NUMBER: M20-60

**SUBJECT: TELEDYNE CONTINENTAL MOTORS (TCM) AIR REFERENCE TUBE REPLACEMENT ON TS10-360GB ENGINES.**

**service bulletin**

**SUBJECT:** TUBE ASSEMBLY (Air Reference Tube)

FIGURE 1

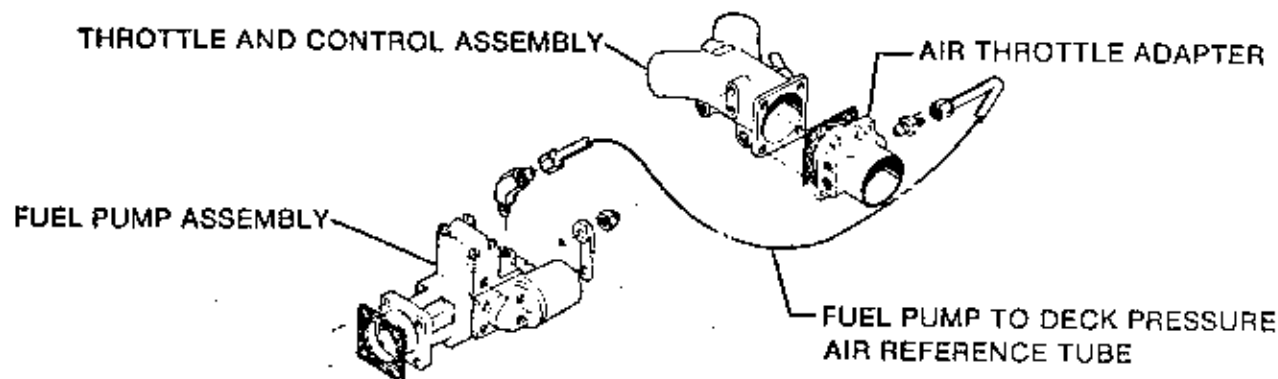
Teledyne Continental Motors has received reports of fractures in the air reference tube, P/N 641082, on engines installed between the air throttle adapter and the fuel pump in Mooney 231 aircraft. See Figure 1.

The tube has been reconfigured to provide additional clearance and the material from which the tube is fabricated has been changed to steel in order to reduce the potential of damage to the tube. The redesigned tube assembly is P/N 646114. (See Parts Catalog, Form X30031A.)

Teledyne Continental Motors recommends that within the next 50 hours or next scheduled maintenance, whichever occurs first, the air reference tube, P/N 641082, on engines installed in affected Mooney 231 aircraft be visually inspected for any cracking, crazing or deformity from its preformed configuration and that any tube having any such discrepancy be replaced with P/N 646114.
